GE Energy

MFN 06-304

Subject: Response to Portion of NRC Request for Additional Information Letter No. 42 Related to ESBWR Design Certification Application – Fire Protection – RAI Numbers 9.5-4 through 9.5-22, 9.5-24 and 15.5-3

**Response to Portion of NRC Request for
Additional Information Letter No. 42
Related to ESBWR Design Certification Application
Fire Protection
RAI Numbers 9.5-4 through 9.5-22, 9.5-24 and 15.5-3**

Figure 9A.2-33. Site Fire Protection Zone ESBWR DCD Plot Plan

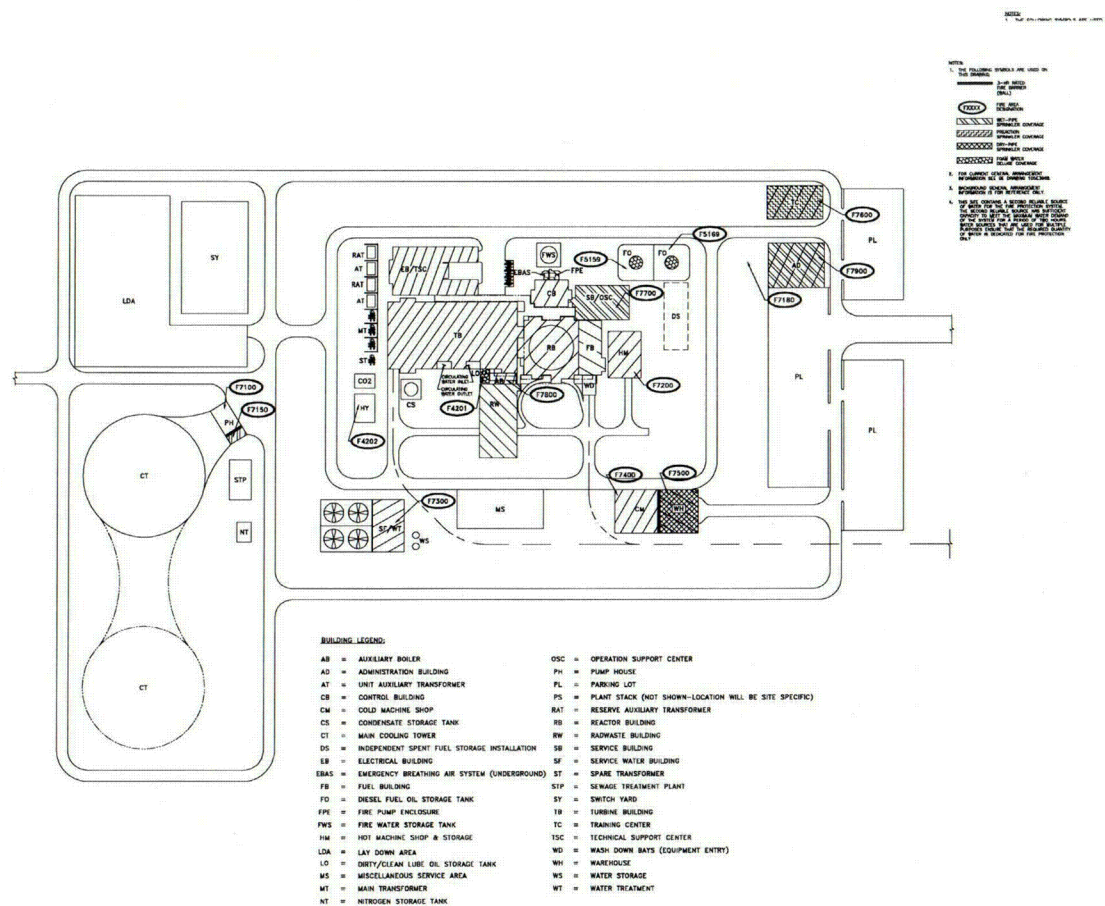
Although this section states that water for the fire protection system is supplied from a minimum of two reliable sources, only a single fire water storage tank is shown on DCD Tier 2, Figures 1.1-1 and 9A.2-22. Presumably these figures reflect a site where an existing fire water storage tank will provide the second fire water system (FWS) tank. A note should be added to the figures to address the requirement for two separate tanks.

Two sources of fire water will be supplied as shown on DCD Tier 2, Figure 9.5-1. The RAI reference to DCD Tier 2, Figure 9A.2-22 should be to DCD Tier 2, Figure 9A.2-33. To clarify, the following note will be added to DCD Tier 2, Figure 1.1-1 (note 3) and Figure 9A.2-33 (note 4).

THIS SITE CONTAINS A SECOND RELIABLE SOURCE OF WATER FOR THE FIRE PROTECTION SYSTEM. THE SECOND RELIABLE SOURCE HAS SUFFICIENT CAPACITY TO MEET THE MAXIMUM WATER DEMAND OF THE SYSTEM FOR A PERIOD OF TWO HOURS. WATER SOURCES THAT ARE USED FOR MULTIPLE PURPOSES ENSURE THAT THE REQUIRED QUANTITY OF WATER IS DEDICATED FOR FIRE PROTECTION ONLY.
